Product Change Notification

1. ECR #: 218869
Notification #: 658

3. Series:
• UMPS - UMPS ASSEMBLY

4. Part #'s Affected
• UMPS-XX-XX.X-XX-V-X-X-XR

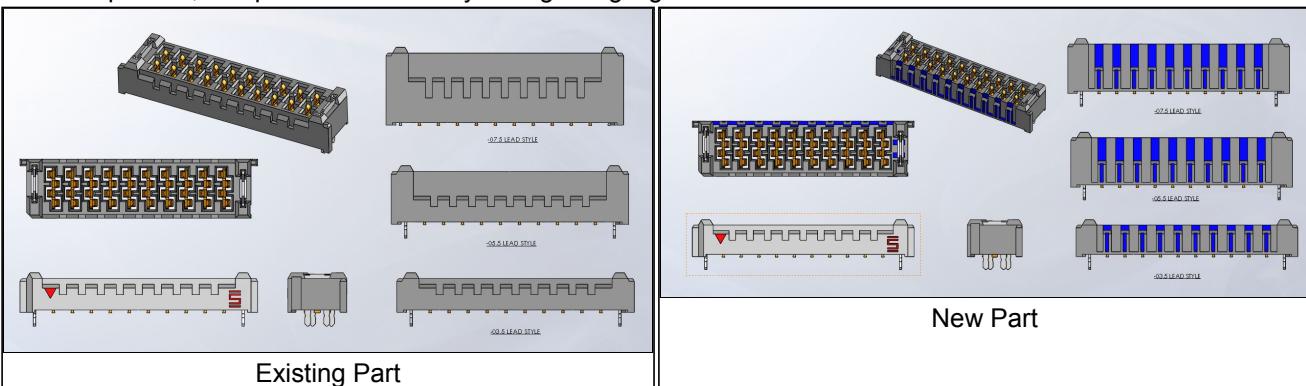
5. Description of Change:
Change the outer void of side rib design and add void to right Weld tab hole.

6. Method of Identifying Change
Visual inspection, see picture for the body changes highlighted in blue color.

7. Reason for Change:
Change made to improve body knit line.
